Permittee: Montanore Minerals Corporation
Operating Permit #: 00150
Location: Libby, Lincoln County
Date: May 2022, Revised August 2022, Revised December 2022

This minor permit revision request follows the format of Administrative Rules of Montana ARM 17.24.120 of the Rules and Regulations Governing the Montana Hard-Rock Mining Reclamation Act.

Montanore Minerals Corporation (MMC or Company) prepared this minor permit revision to Hard Rock Operating Permit No. 00150 for the Libby Exploration Project (Project). MMC holds Operating Permit No. 00150 authorizing completion of the Libby Adit and construction, operation, and reclamation of the Project. Exploration activities were authorized at the Libby Adit Site in Exploration License No. 00429, issued on April 19, 1989. The license was later incorporated into Operating Permit No. 00150 issued in 1993. Since then, minor revisions have been authorized by the Montana Department of Environmental Quality (DEQ) as follows:

Exploration Project Facilities
at the Libby Adit Site
Libby Exploration Project
Lincoln County, Montana
FIGURE 1

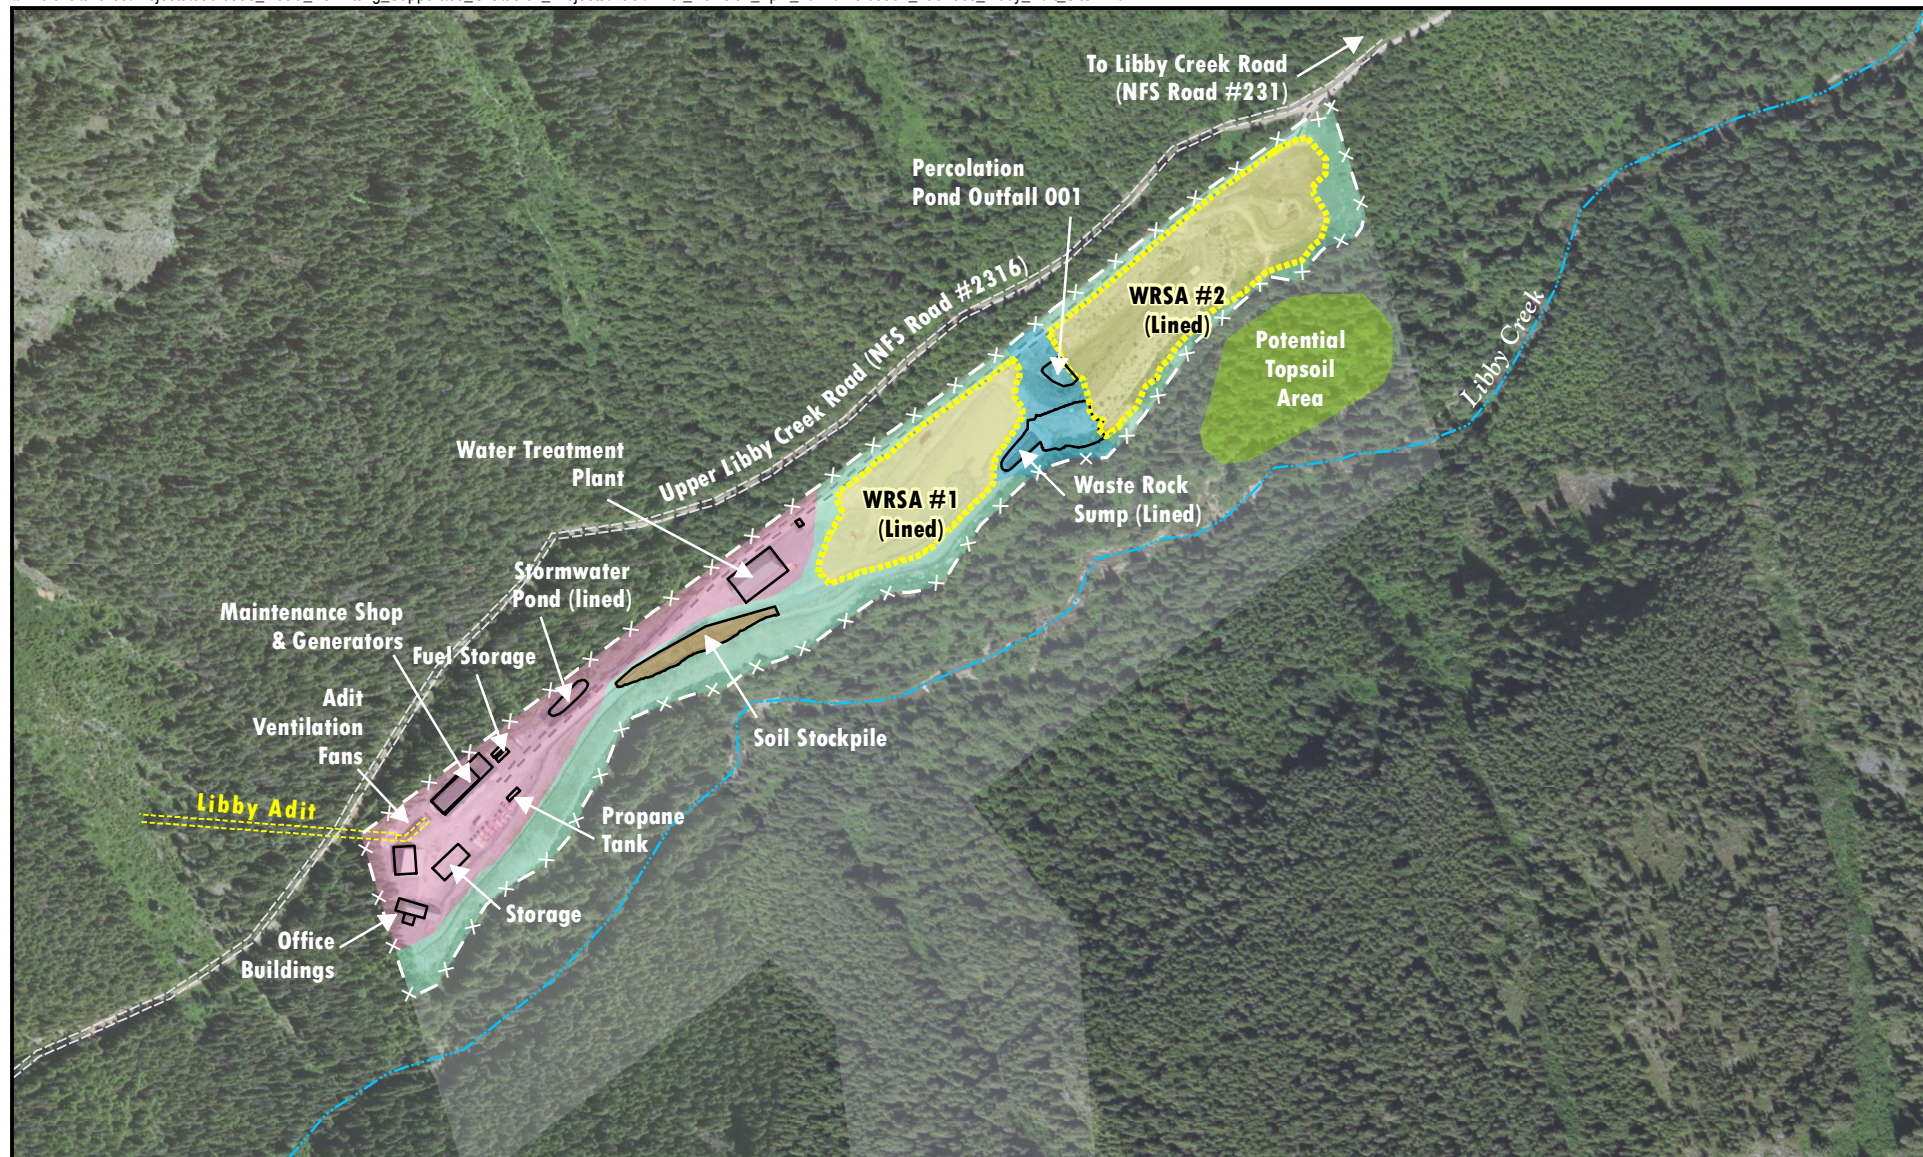
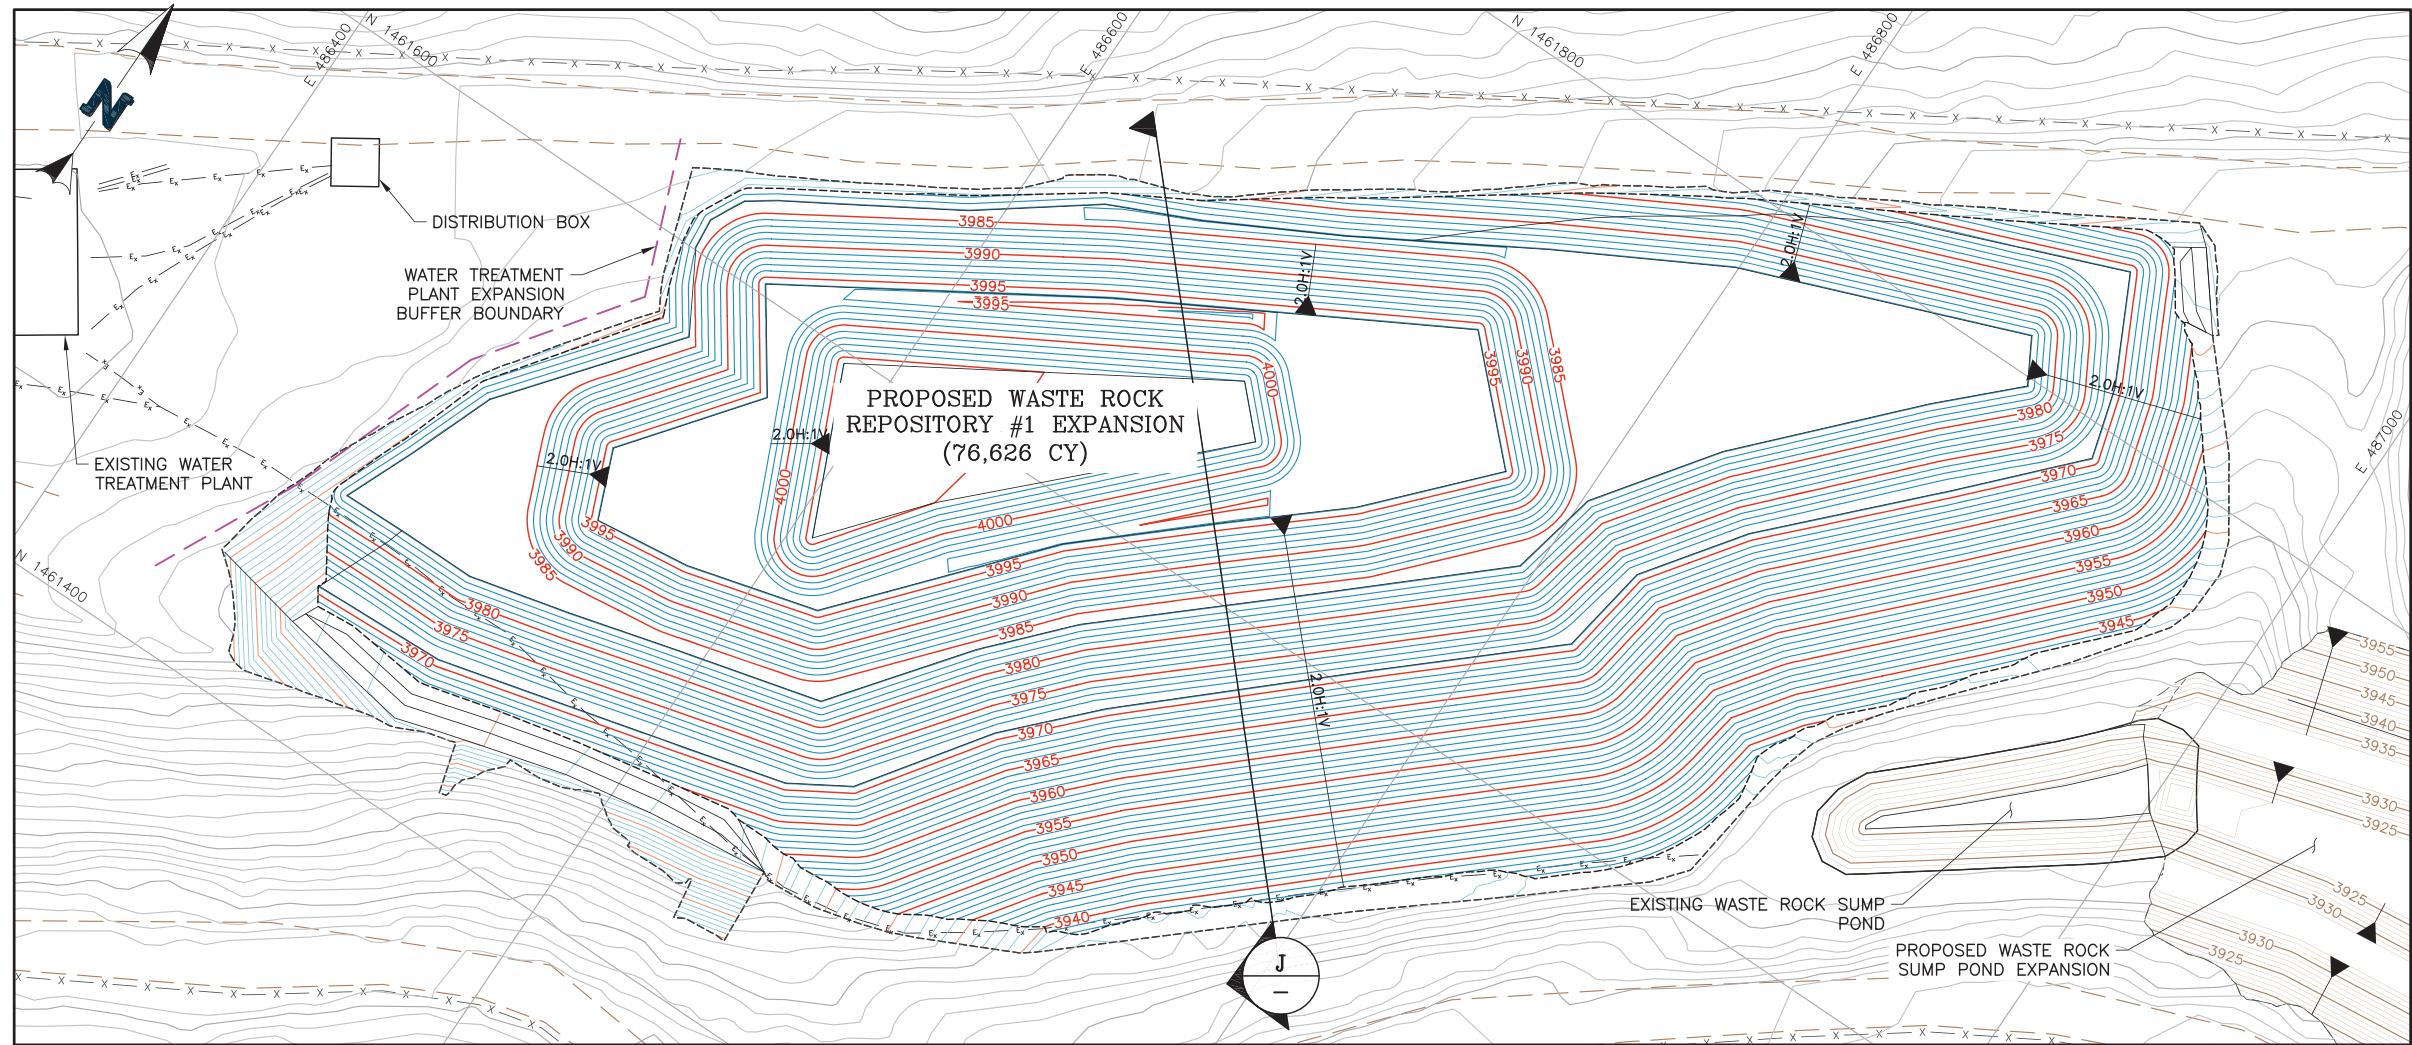
All surface facilities will remain within the previously disturbed area at the Libby Adit Site. No new disturbances will be created as an outcome of the modifications presented in this minor revision. **Table 1** presents the area for the Libby Adit Site facilities associated with this minor revision. **Figure 1** shows the change in surface facilities at the Libby Adit Site.

Topsoil (growth media) has been removed and stockpiled at the Libby Adit Site for use during reclamation. Approximately 15,200 yd³ of topsoil is stockpiled at the site. MMC will develop a new soil stockpile at the southeast portion of the Libby Adit Site (**Figure 1**). MMC will move the existing soil stockpile (approximately 2,000 yd³) located within the footprint of WRSA #2 to the new soil stockpile. Topsoil stockpiles will be depleted once MMC spreads the material over the Libby Adit Site for reclamation of facilities. The stockpile areas will be regraded and contoured, ripped, and scarified to loosen compacted soil. MMC will establish vegetation using the approved seed mix. MMC does not anticipate purchasing topsoil from an outside source.

MMC proposes to evenly distribute topsoil to reclaim facilities at Libby Adit Site. Development of WRSA #2 will require disturbing existing revegetated slopes on the south side of the Libby Adit Site and on the northeast side of WRSA #2. MMC will salvage available soil material and store the material in the new topsoil stockpile. Areas such as road cuts may not require placement of topsoil at closure. MMC will complete an assessment of areas that require placement of topsoil and may use organic amendment to improve revegetation. MMC will assess the need for topsoil material to meet closure objectives based on specific areas at the Libby Adit Site. Should the assessment demonstrate that there is an insufficient volume of topsoil available, MMC will investigate the area located south of WRSA #2 (down to Libby Creek, as shown on **Figure 1**) as a potential source of growth media.

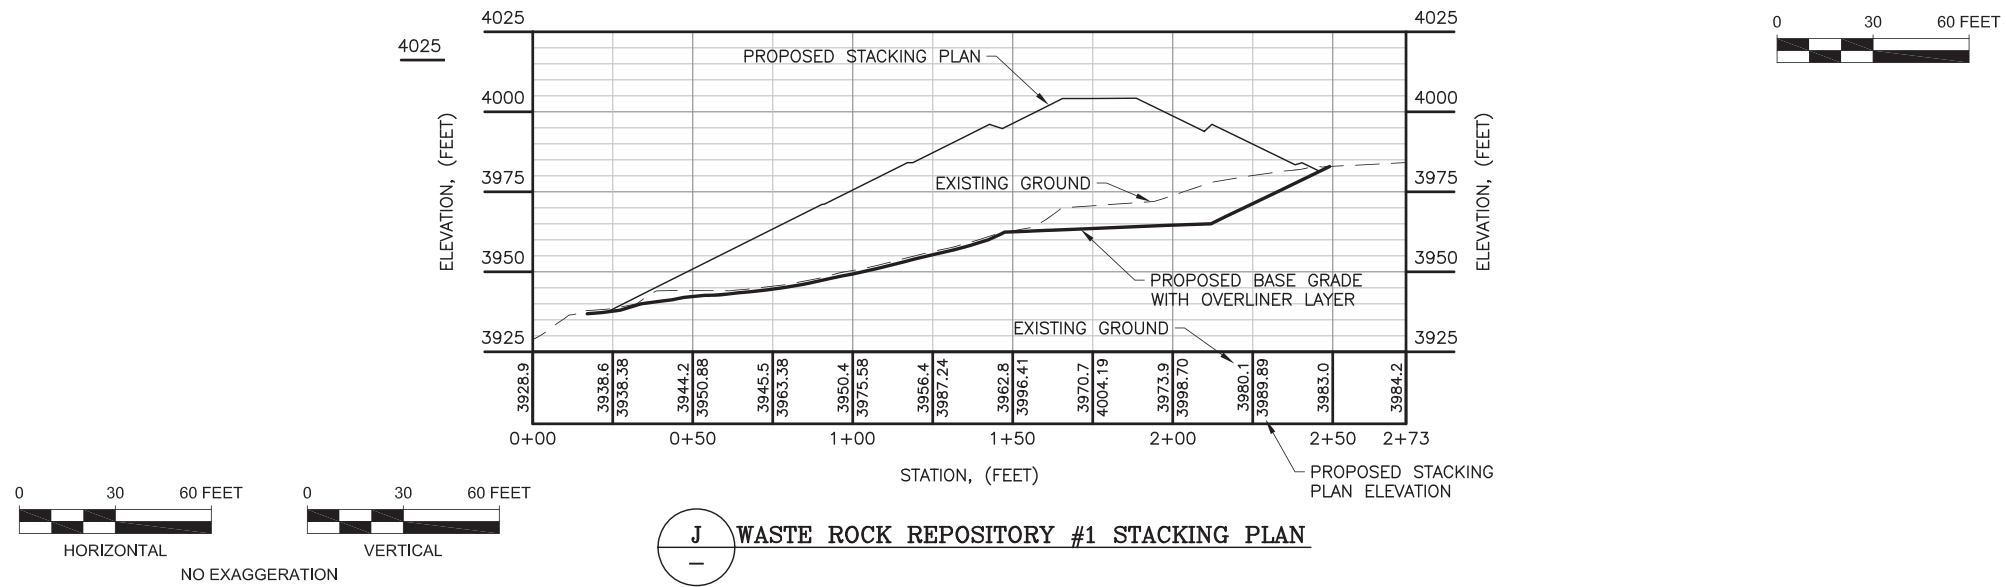
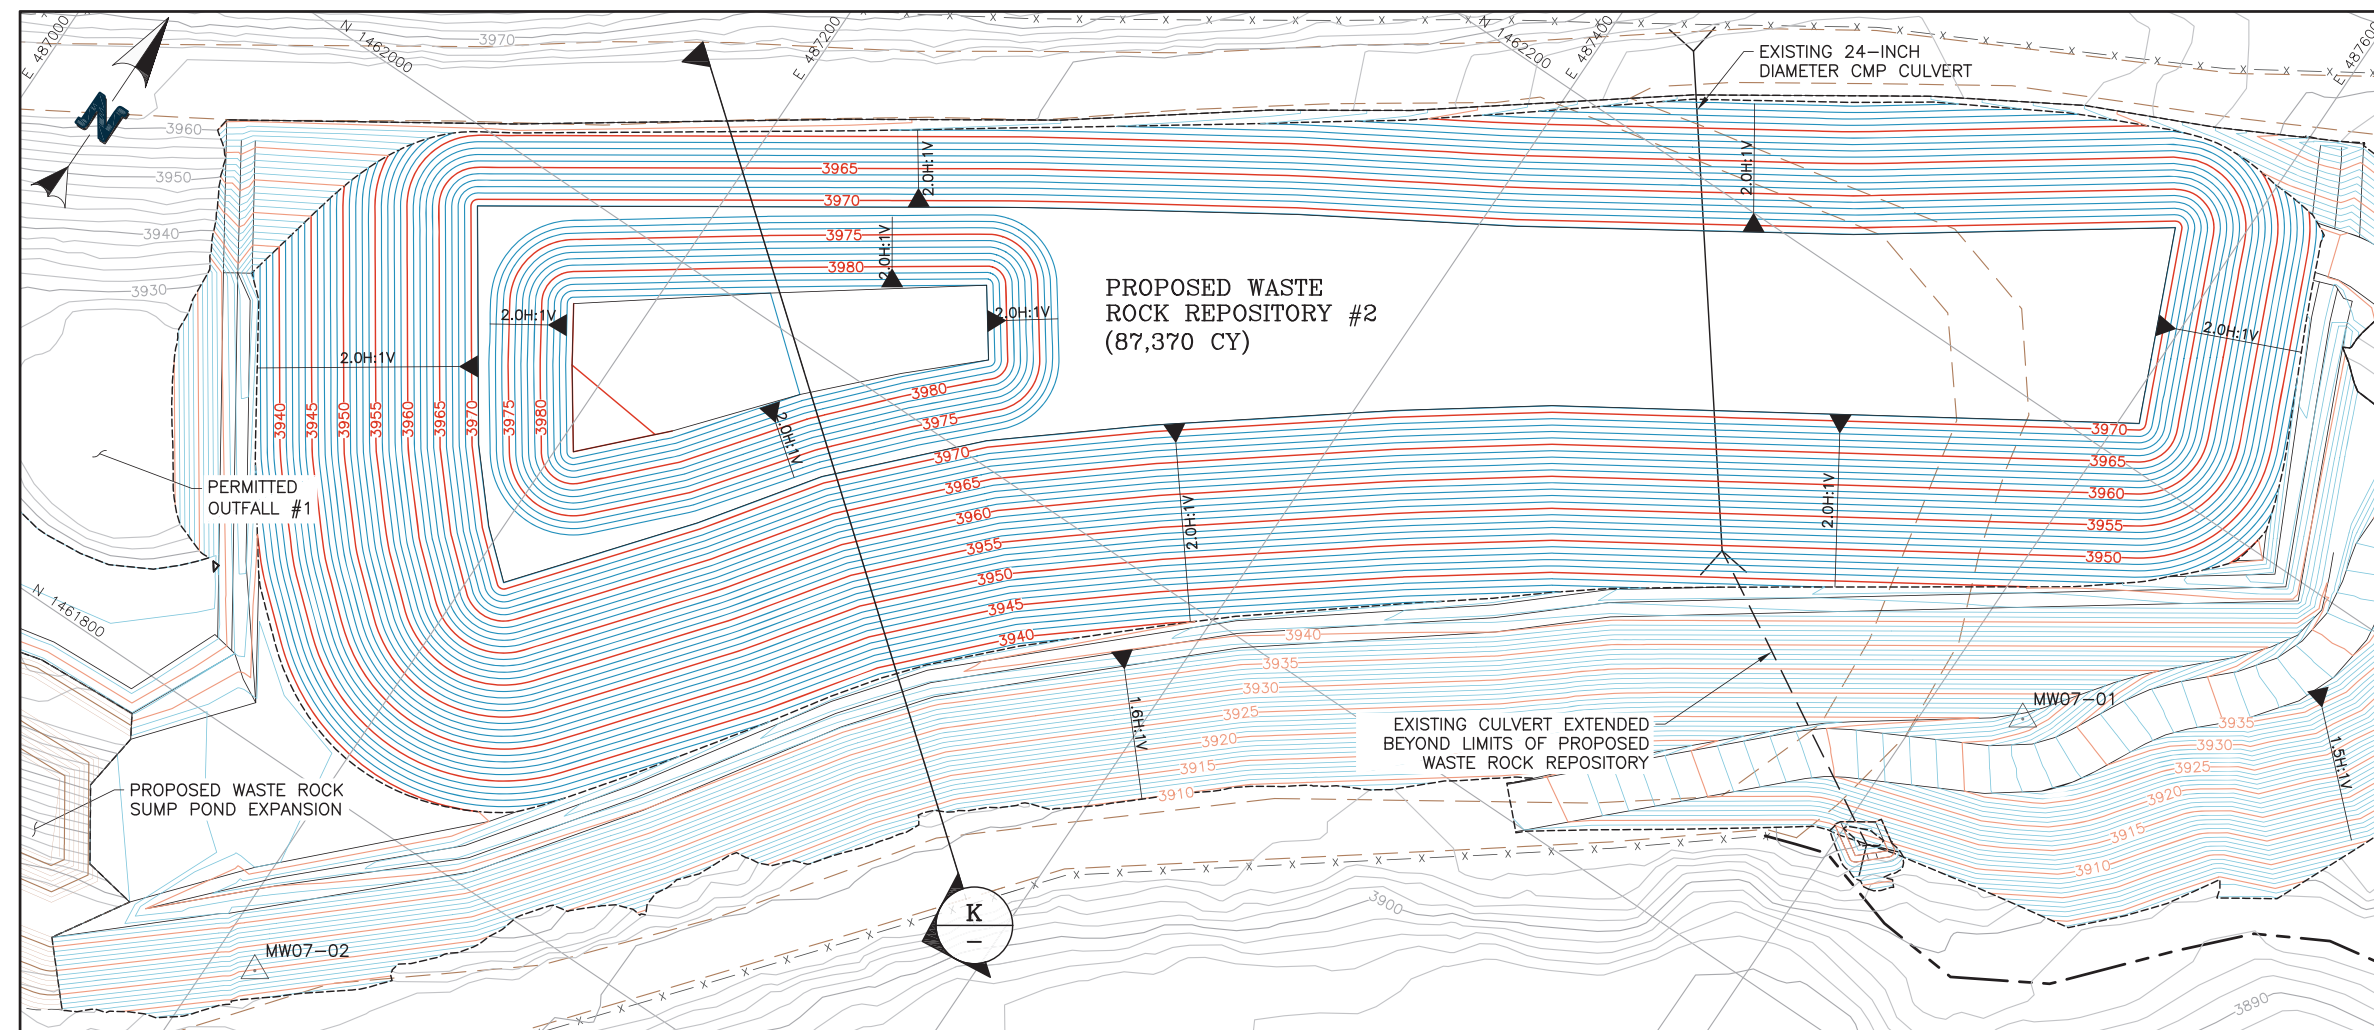
MMC will extend existing WRSA #1 northwest from the edge of the existing lined area toward the WTP. The expansion of WRSA #1 will include installation of a polyvinyl chloride (PVC) geomembrane liner that ties into the existing PVC liner and anchored along a perimeter berm. A plan view and cross-section of WRSA #1 is shown on **Figure 2**. The total storage capacity for WRSA #1 will be approximately 77,000 yd³.
